## NOVI PET RESORT JSP23-20

Consideration of Preliminary Site Plan and Storm Water Management Plan approval at the request of Stucky Vitale Architects for a pet boarding facility. The subject property is approximately 2.31 acres and is located north of Ten Mile Road on the west side of Novi Road at Gen Mar in the I-1, Light Industrial Zoning District. The applicant is proposing to construct a 9,350 square foot pet boarding facility with 20 parking spaces and a 2,509 square foot outdoor animal play area with artificial turf.

Approve or Deny the Preliminary Site Plan and Storm Water Management Plan, along with any applicable waivers.

<b>REVIEW</b>	<b>RESULT</b>	<b>DATE</b>	<b>COMMENT</b>
Planning	Approval recommended	8-9-23	<p><b>Zoning Board of Appeals Variance for building setback of 35 feet (40 feet required, 5 feet proposed) along the west property line</b></p> <p><b>Zoning Board of Appeals Variance for outdoor facilities location in the front yard (interior side or rear yard required) and for a 30 foot variance of setback from the property line (40 feet required, 10 feet proposed) along the west property line</b></p> <p><b>Zoning Board of Appeals Variance for location of dump

DRAWING: **C-2**

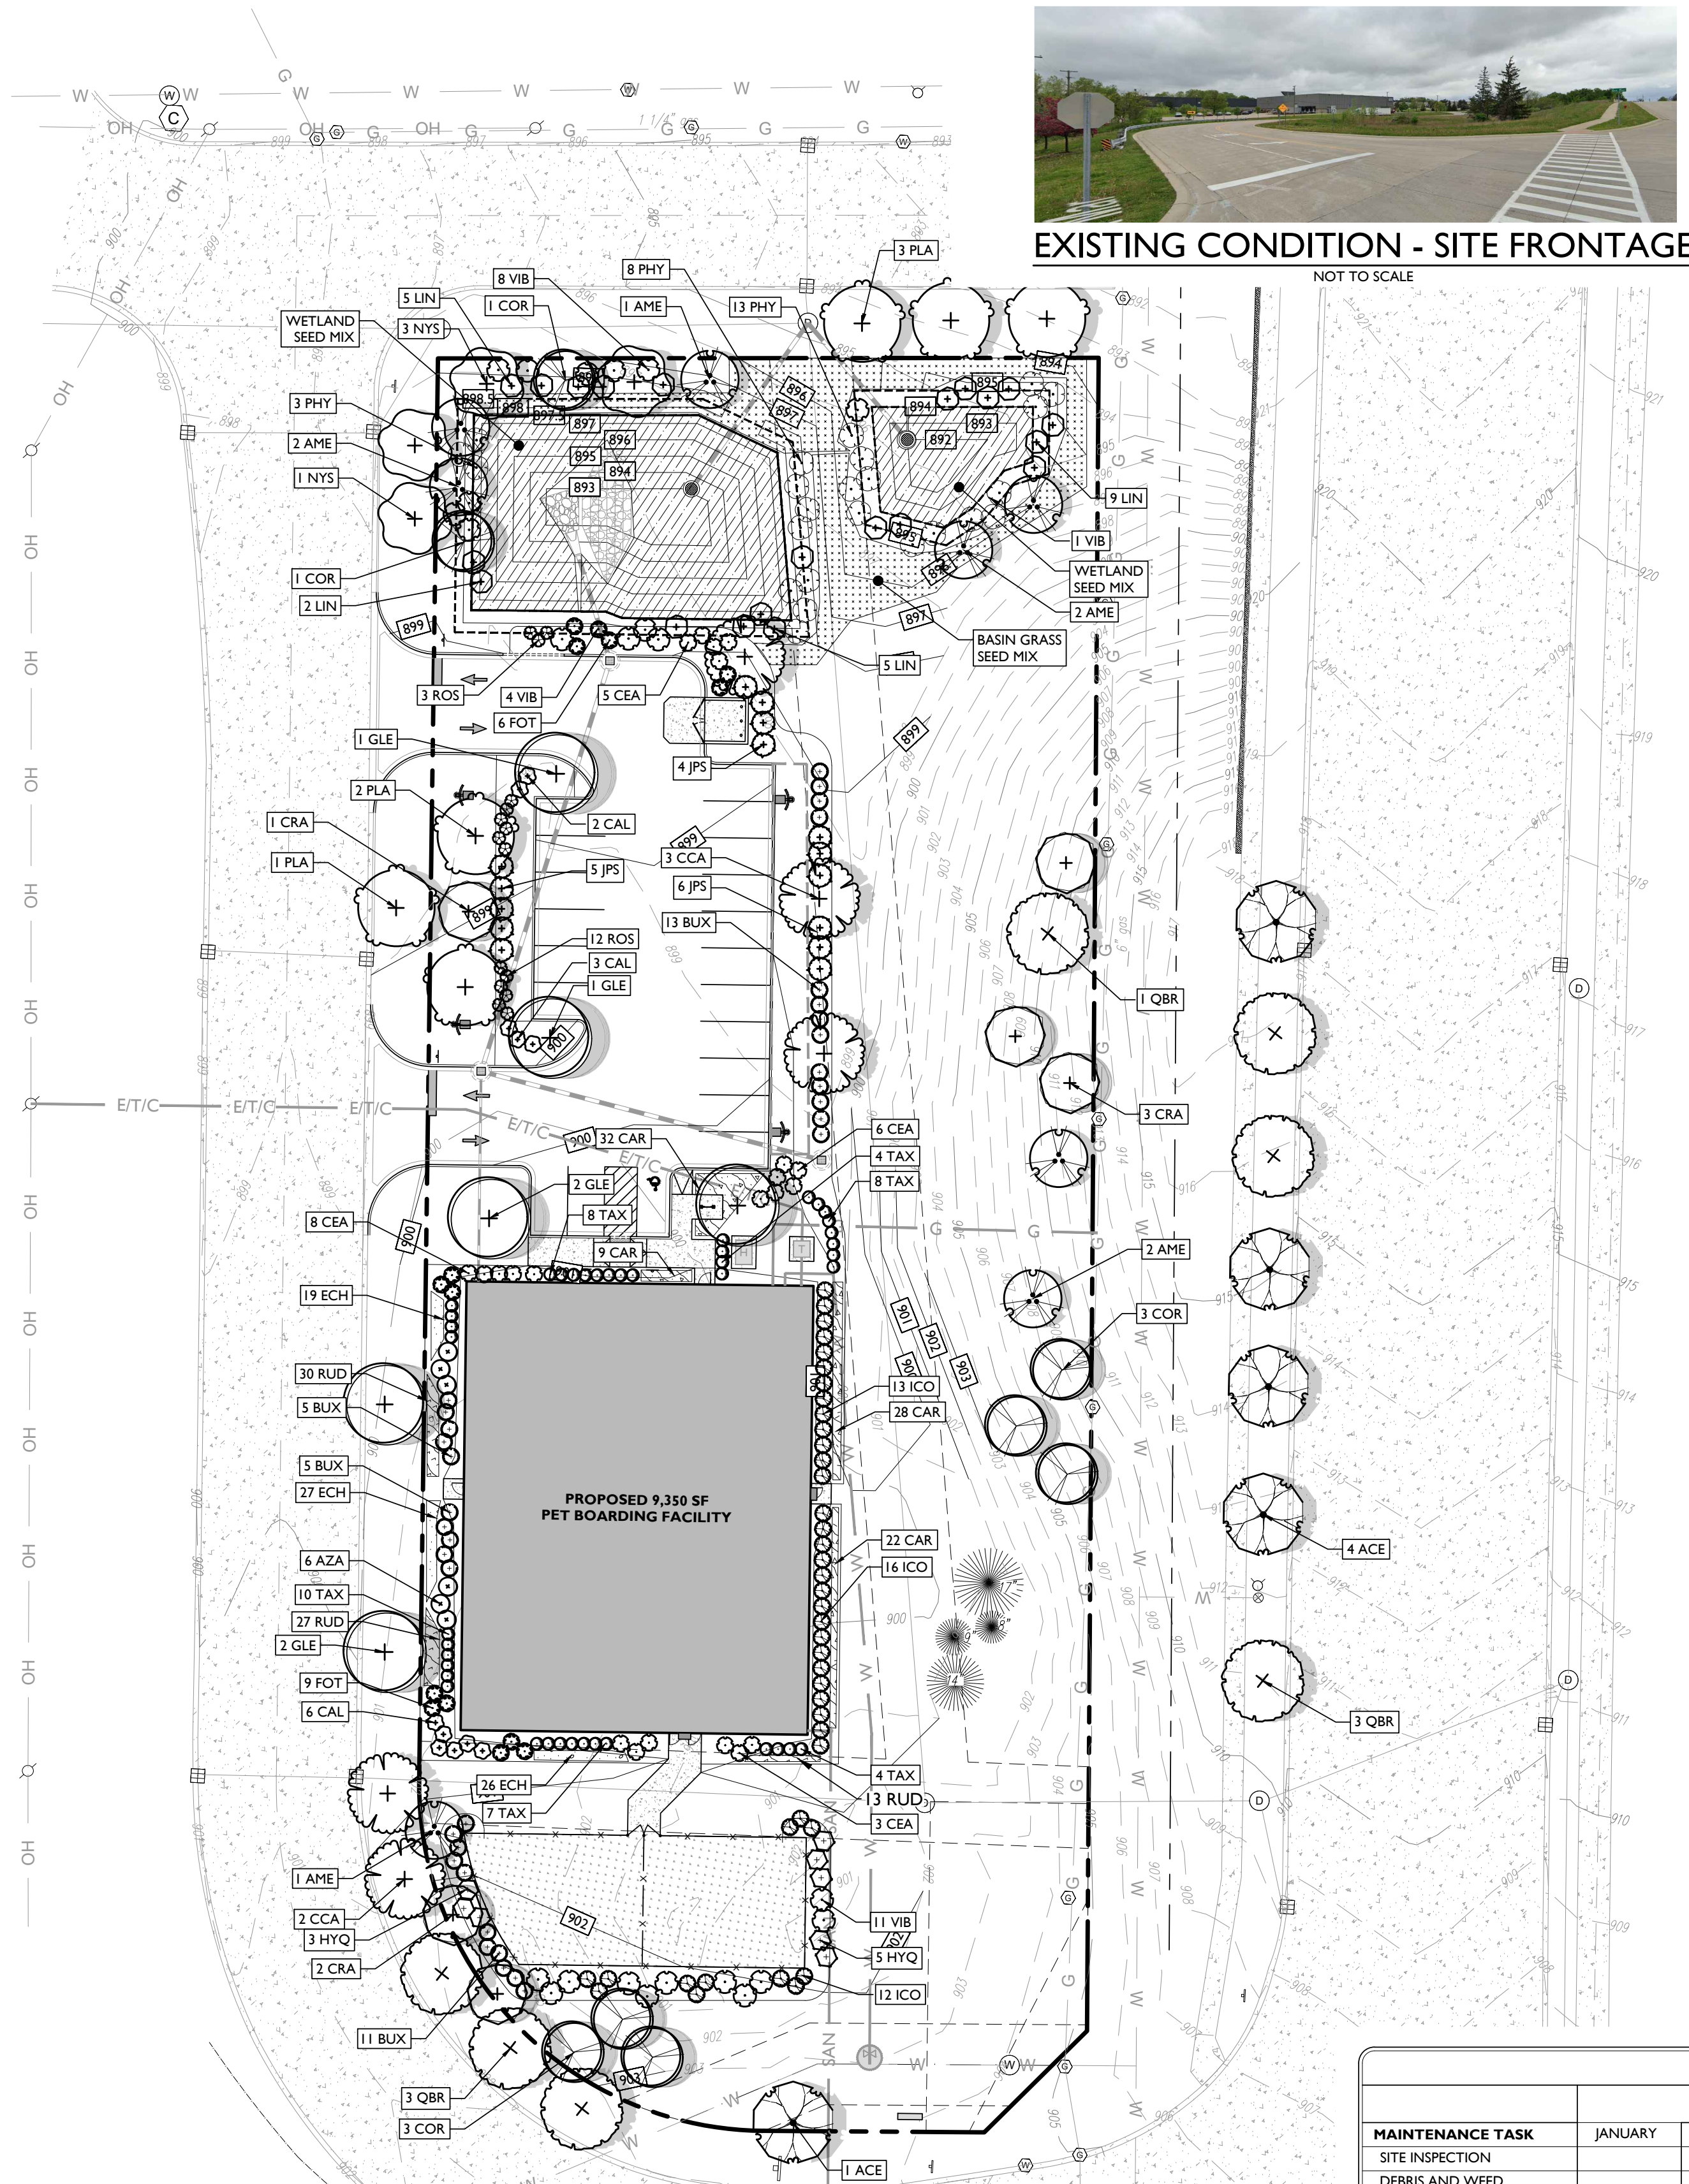
4. Pickups and Drop-offs (Sec. 4.46.3): *Adequate traffic circulation shall be provided on the site to accommodate the frequent pickups and drop-offs of animals for the facility. Note added to sheet C-2: "animal pick-up and drop-off shall be accommodated in an efficient manner as to not disrupt traffic circulation."*

Item	Required Code	Proposed	Meets Code	Comments
	All animal waste shall be removed from the outdoor area daily and disposed of in a sanitary manner.	Note 14 under General Notes on sheet C-2 indicates this standard will be met	Yes	
	Pets shall not be permitted to remain outdoors overnight.	Note 13 under General Notes on sheet C-2 indicates pets shall not stay outside overnight	Yes	
<b>Animal Waste</b> (Sec. 4.46.5)	Animal wastes, biohazard materials or byproducts shall be disposed of as recommended by the Michigan Department of Public Health, and/or other duly appointed authority at the discretion of the City. All other wastes shall be contained in leak-proof and odor proof containers. No animal wastes, biohazard materials or byproducts shall be buried, composted, or incinerated on-site, or allowed to enter into groundwater.	Note 14 under General Notes on sheet C-2 indicates this standard will be met	Yes

<b>Noise</b> (Sec. 4.46.6)	Noise shall be minimized through the combined use of screening, site isolation, and sound dampening materials in compliance with Sections 5.5, 5.11, and 5.14  I-1 district decibel limits: - 70 decibels during night hours - 75 decibels during day hours	Note 15 under General Notes on sheet C-2 indicates this standard will be met	Yes

**Acknowledged. Please refer to the above Request for Waivers / Variances. A greenbelt of 25 FT was maintained in the western exterior side yard. Shifting the parking east would encroach into an existing 20 FT wide drain easement running through the site as well as a severe (20 FT) grade change within the eastern portion of the site. Refer to sheet C-2 of the Site Improvement Plans for the proposed parking setbacks.**

**Please refer to the above Request for Waivers / Variances. The applicant is requesting a modification to the setback requirements to maintain an equal / greater setback area. The required setback area is 39,963 SF and the proposed setback area is 39,996 SF. Refer to the first footnote of the 'Land Use and Zoning' table on Sheet C-2 of the Site Improvement Plan.**

**Parking details & dimensions per the City of Novi ordinance will be added to Sheet C-2. Two bicycle parking spaces are proposed adjacent to the main building entrance on the northern façade and the layout will be updated per the provided engineering comments & zoning dimensional requirements.**

**Driveway radii have been indicated, refer to Sheet C-2 of the Site Improvement Plan.**

**End islands have been updated to be 3 FT shorter than adjacent parking spaces. Refer to Sheet C-2 of the Site Improvement Plans.**

**2 Bicycle parking spaces are proposed adjacent to the main building entrance on the northern façade. Refer to sheet C-2 of the Site Improvement Plan, and detail #11 on C-12. As requested, as separate dimensional detail will be added to Sheet C-2 and the layout will be revised per all applicable requirements set within the City zoning ordinance.**

**Stop bar and arrows remain shown on the site plan, and are to be painted on-site. Refer to Sheet C-2 for locations.**
